Model: Multi Bypass Tray BY5000 (B833)		Date: 25-Mar-11	No.: RB833001
Subject: Part change – Push Switch and Harness		Prepared by: T. Komori	
From: PP Service Planning Department 1G			
Classification:	<input type="checkbox"/> Troubleshooting <input type="checkbox"/> Mechanical <input type="checkbox"/> Paper path <input type="checkbox"/> Product Safety	<input checked="" type="checkbox"/> Part information <input type="checkbox"/> Electrical <input type="checkbox"/> Transmit/receive <input type="checkbox"/> Other ()	<input type="checkbox"/> Action required <input type="checkbox"/> Service manual revision <input type="checkbox"/> Retrofit information <input type="checkbox"/> Tier 2

Model: Multi Bypass Tray BY5000 (B833)		Date: 16-Dec-11	No.: RB833002
Subject: Part Changes		Prepared by: A. Takada	
From: PP Tech Service Dept., 1st PP Tech Service Sect.			
Classification:	<input type="checkbox"/> Troubleshooting <input type="checkbox"/> Mechanical <input type="checkbox"/> Paper path <input type="checkbox"/> Product Safety	<input checked="" type="checkbox"/> Part information <input type="checkbox"/> Electrical <input type="checkbox"/> Transmit/receive <input type="checkbox"/> Other ()	<in

3.Original Tray 2 (B833)

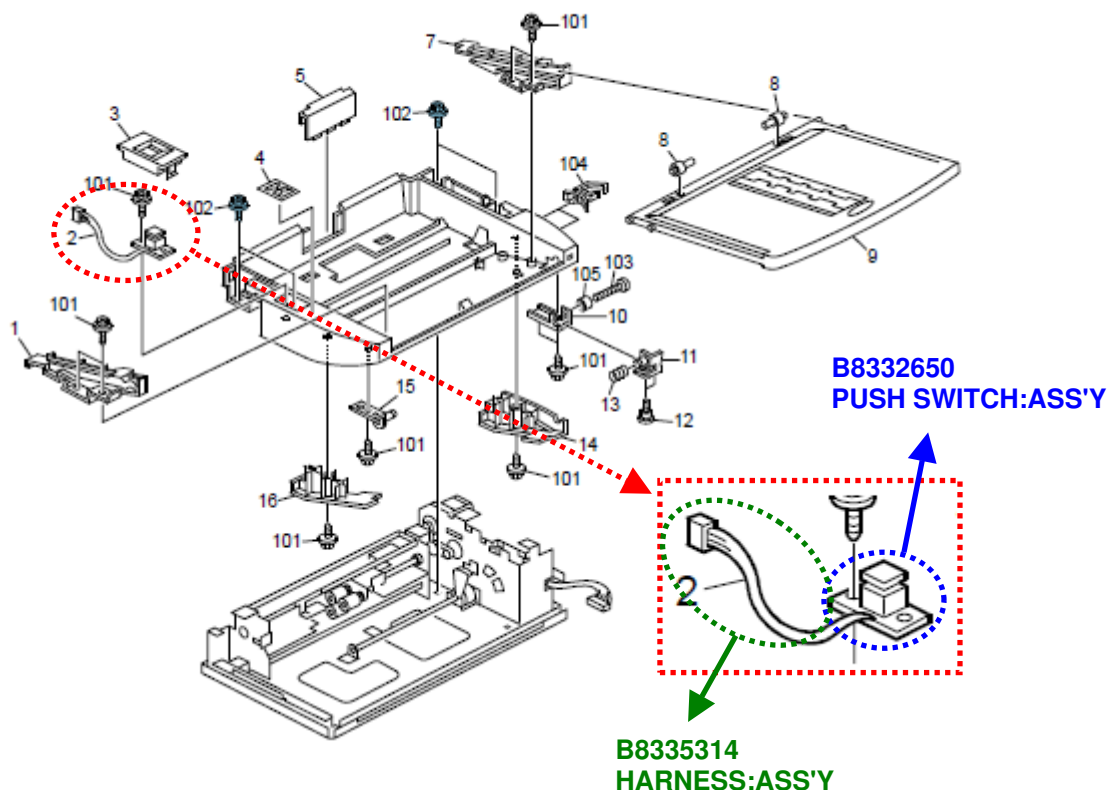
Change: Part number

Reason: Change in the parts vendor

Old Part Number	New Part Number	Description	Q'ty	Int	Page	Index	Note
B8335170	B8332650	PUSH SWITCH:ASS'Y	1	O/O	as a	7	2
	B8335314	HARNESS:ASS'Y	1		set	7	17
							add

The push switch previously assigned with one p/n has been reassigned with two separate p/n for the switch and the harness respectively.

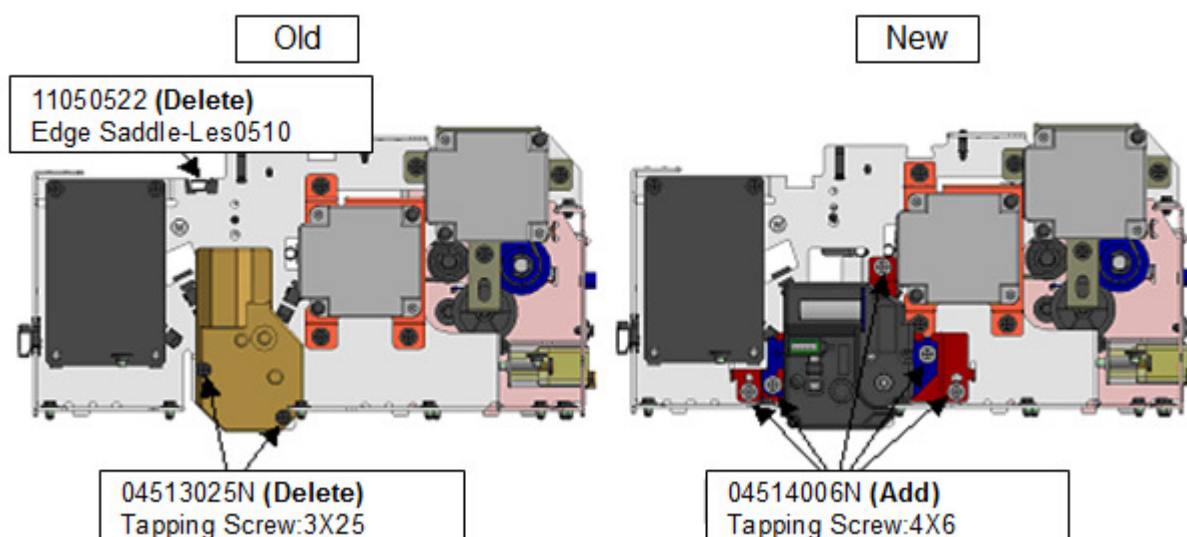
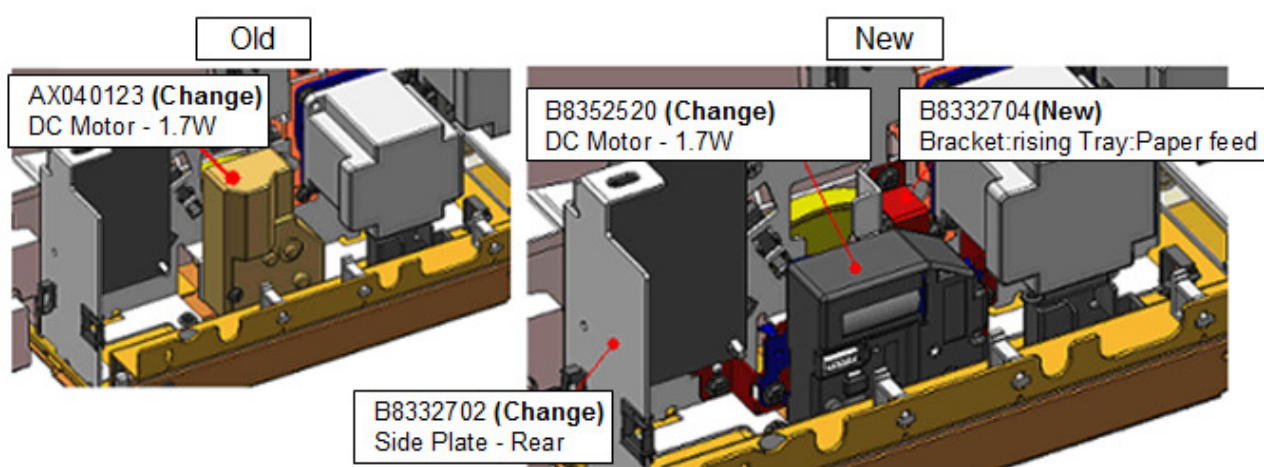
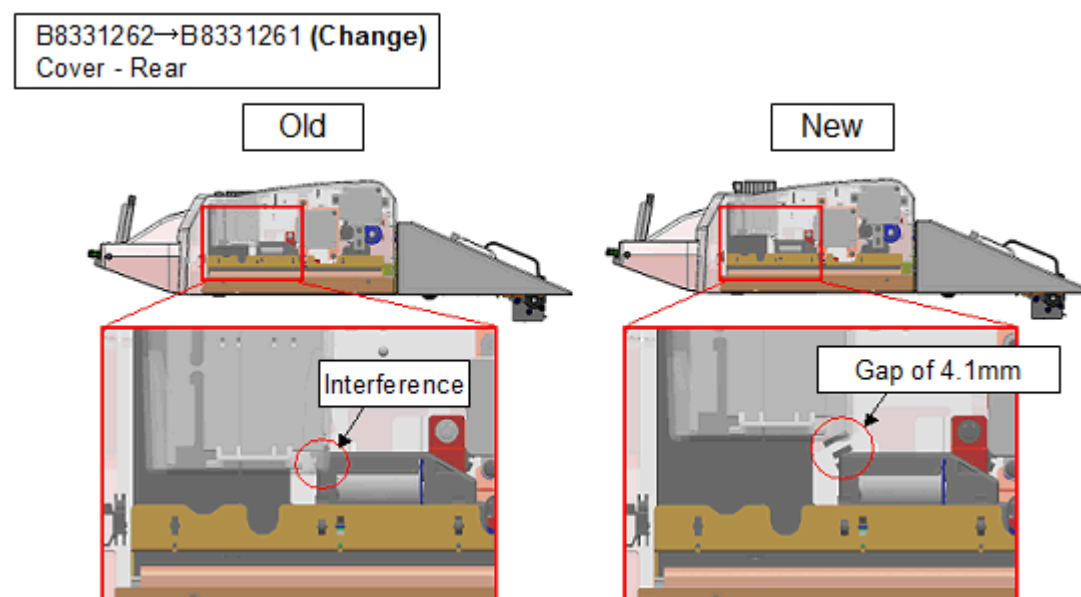
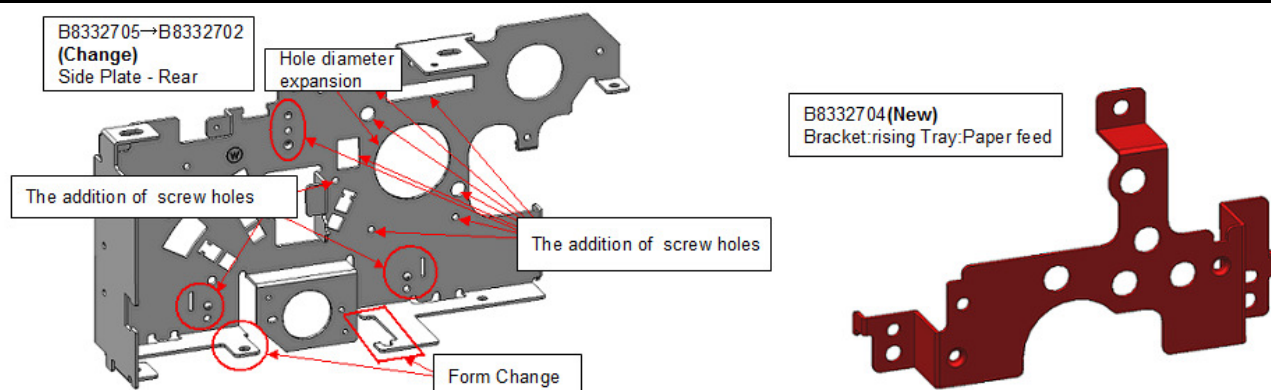
Change: DC Motor-1.7W and its accompanying parts

Reason: Change in the vendor of the motor

Old Part Number	New Part Number	Description	Q'ty	Int	Page	Index	Note
AX040123	B8352520	DC Motor - 1.7W	1	X/O	15	15	A
B8331262	B8331261	Cover - Rear	1	X/O	3	8	A
-	B8332704	Bracket: Rising Tray: Paper feed	1	-	15	19	A
B8332705	B8332702	Side Plate – Rear	1	X/O	15	7	A
B8335303	B8335313	Harness – Sensor	1	X/O	15	13	A
C4165301	B8335311	Harness: Drawer: Plug: Ass'y	1	X/O	9	7	A

When replacing any of the above parts, replace all 6 parts as a set using the following screw:
